**MarkWest Houston Gas Plant  
Inspection Report  
Chartiers, Pennsylvania**

Region III Office of Air Enforcement & Compliance Assistance  
Inspection Date: April 28-30, 2015

2. ISS Leak Tag on Flange 001703 – MarkWest Houston – 04/28/2015

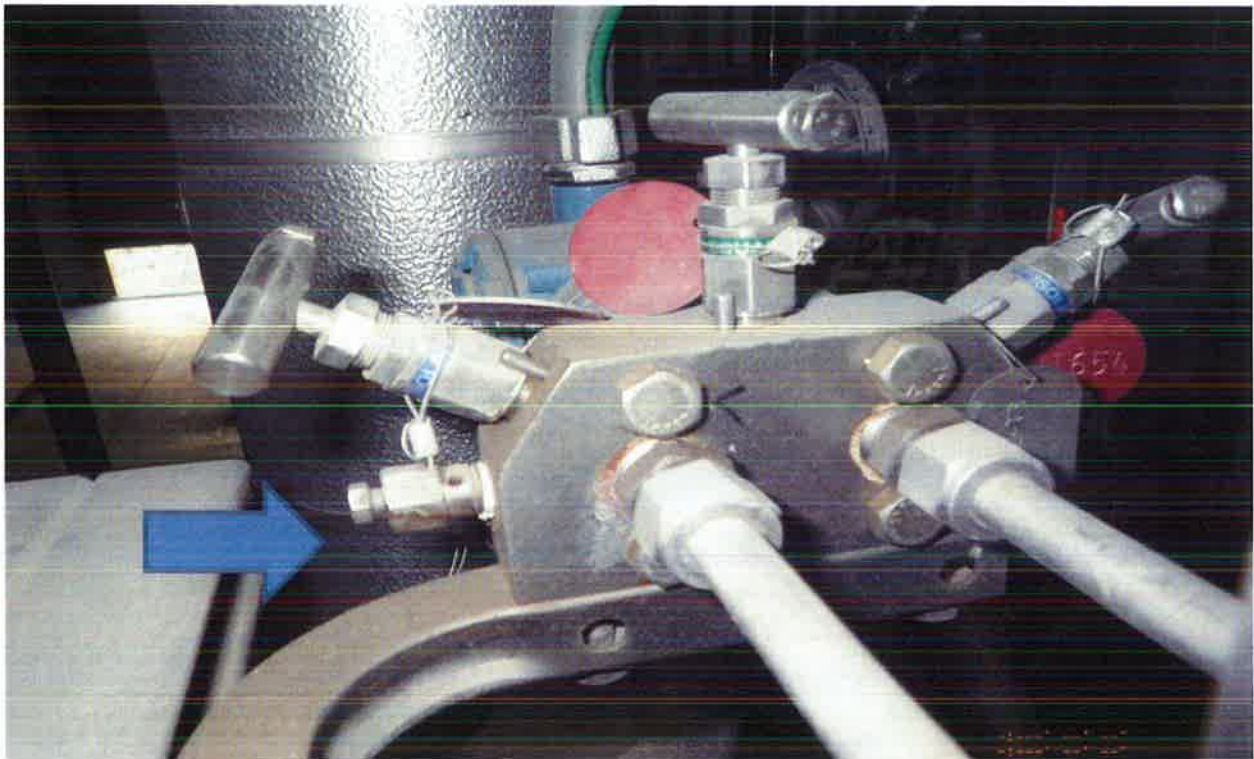
- There were six new stainless steel valves observed on the H1 inlet line near component 000195 that were not identified as part of the LDAR program.
- An LDAR leak tag was observed on component 1703.1 that was leaking on 12/12/13. No recheck date was listed on the LDAR tag (See Photo 2 on Page 1 of Inspection Photos).
- Multiple LDAR tags (24) were observed on the residue line in this area.<sup>5</sup>

4. Bleeder Valve next to 001656 not tagged for LDAR – MarkWest Houston – 04/28/2015

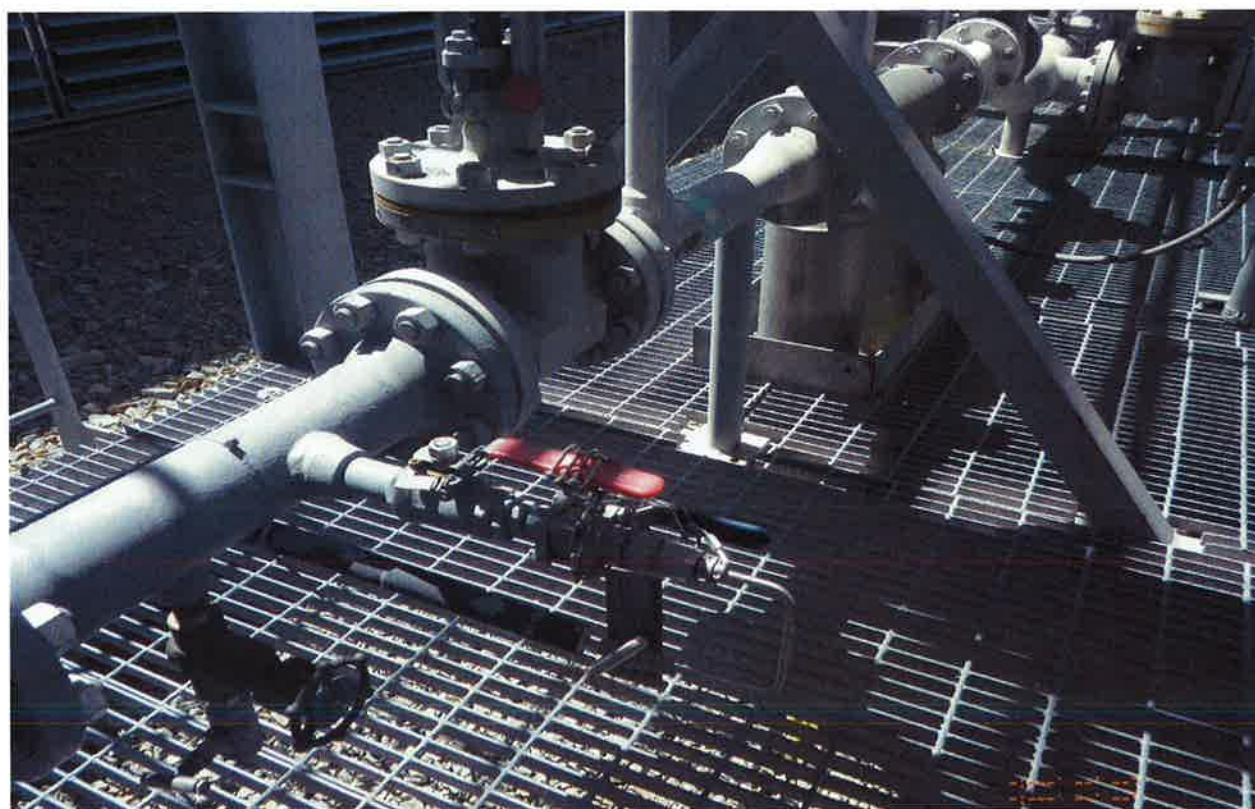
- Two valves to the left of 004368 have no tags and three valves above tag 004353 are not tagged. Six additional unmarked valves were observed in Frac 1.
- One open ended line at 004348 was observed and was leaking with a concentration of 600ppm. This leak was confirmed by ISS with a reading of 1428ppm
- All bleeder valves that are part of the instrumentation assemblies (also called vent plugs) are not tagged as part of the LDAR program for the facility (See Photo 4 on Page 2 of the Inspection Photos).

14. Mariner East Propane Pipeline Untagged for LDAR – MarkWest Houston – 04/29/2015

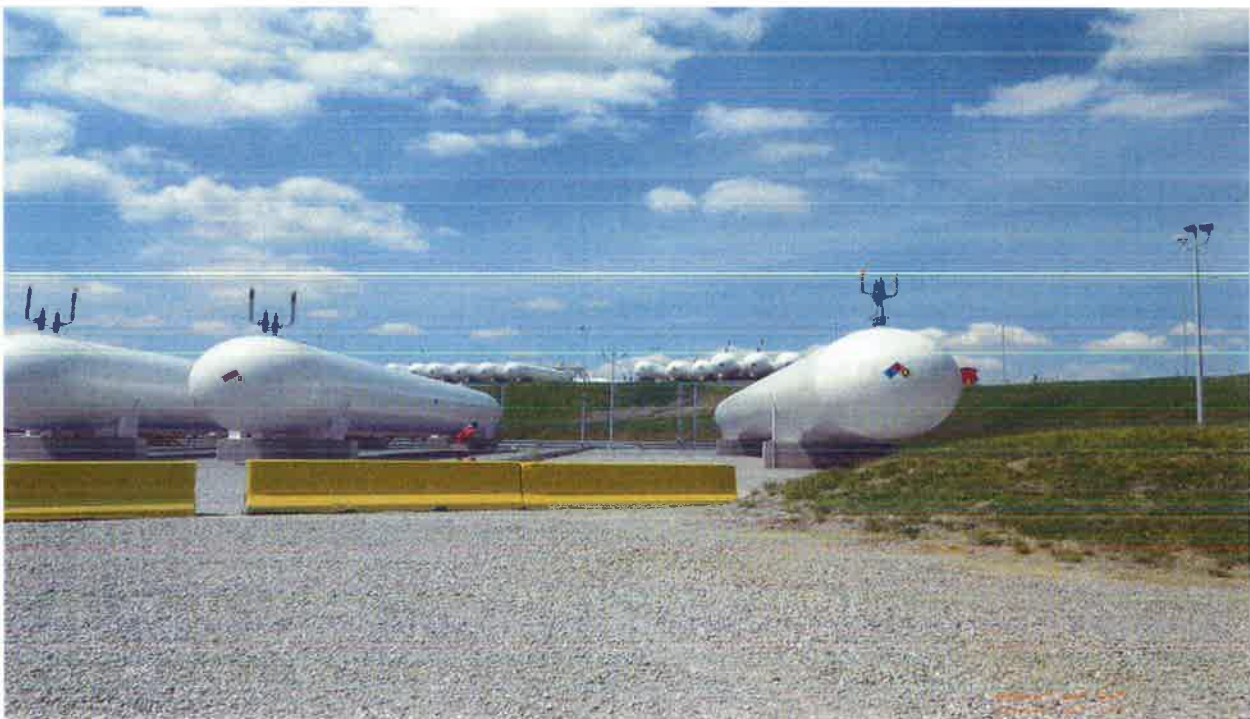
- The Mariner East Pipeline<sup>6</sup> runs adjacent to the facility and there is a tie-in on MarkWest property. There are no LDAR tags on this line.
- There are sporadic tags in the propane refrigeration building with some lines being tagged partially while the remainder of the line isn't tagged.
- EPA observed several hundred LDAR tags on lines downstream of the De-ethanizers which should not be included in the LDAR system.
- At least five valves were observed on insulated lines with no access port for LDAR monitoring.
- There were no LDAR tags on any equipment located in Storage Pad 3. There are nine bullet tanks in this area.

15. Pad 3 N-Butane Storage Bullets – MarkWest Houston – 04/29/2015

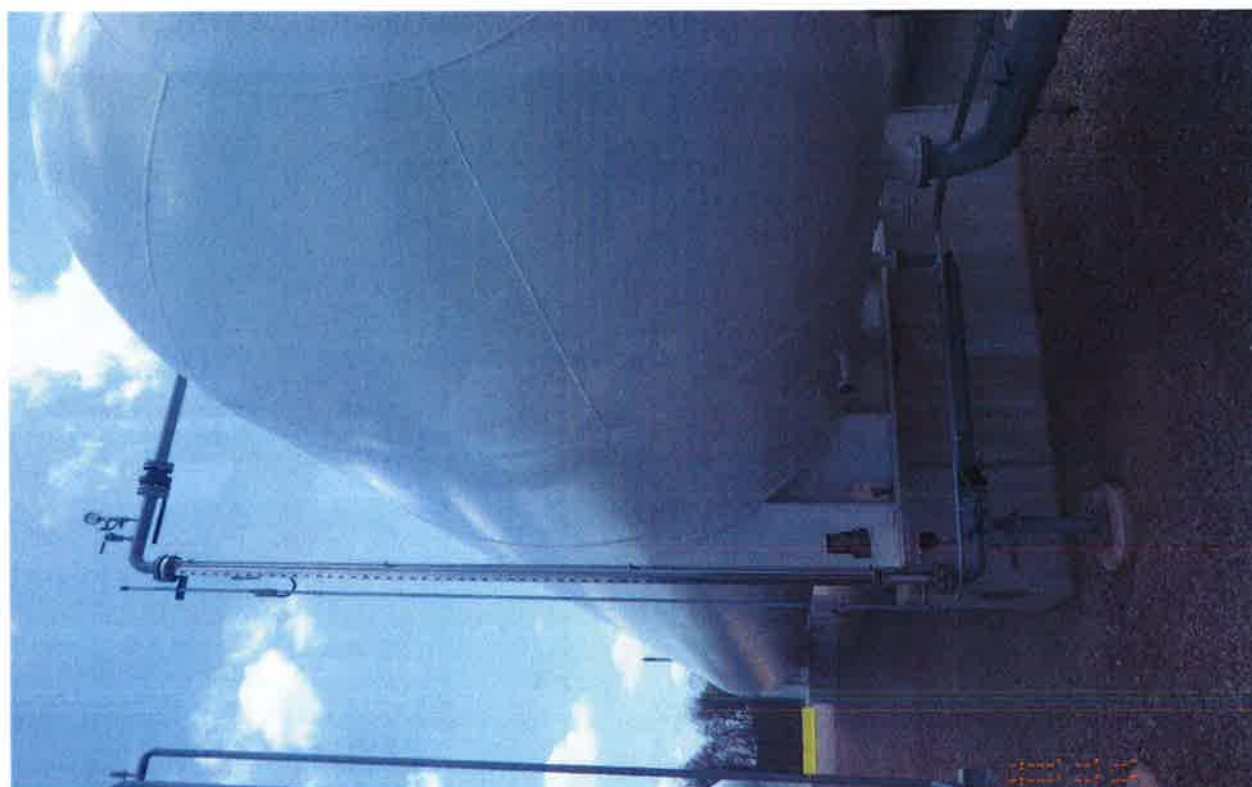
6. There were no LDAR tags and all of the components in the Storage Pad 3 (Nine n-butane storage tanks) were not included in the LDAR program. Mark West commenced identifying and tagging this area while the inspection was ongoing. After the inspection MarkWest stated that 281 valves, 660 connectors, and 18 process safety valves were tagged in this area.
